Access Compliance Report

Public Rights-of-Way

(Curb Ramps)

Intersection ID: 10036656	Main Street: S_CALDWELL_ST	Cross Street: N/A	Location: SE
ADA ID: A50F931FBC57	Ramp Type: Directional1	Initial Pass/Fail: Fail	Overall Compliance: No
Codes/Mitigation Info/Possible Solution		Field Measurements/Component Compliance	
Severity Score: 13.75

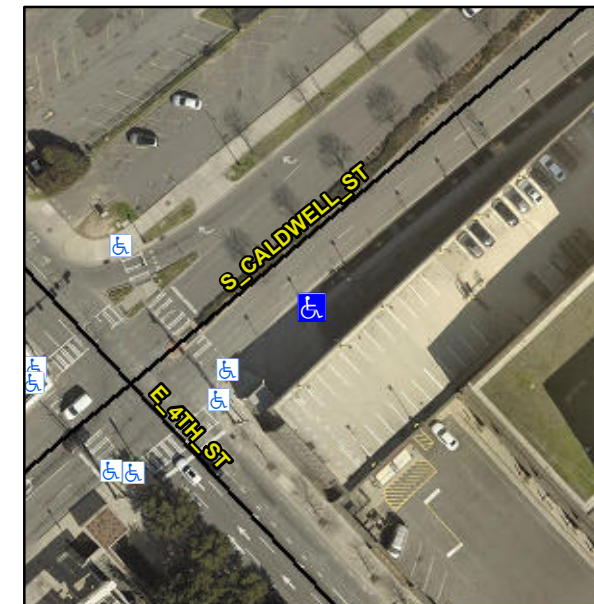
CURB LIP 1.0"

R304.2.2, R304.5.3

Remove & Replace Entire Ramp.
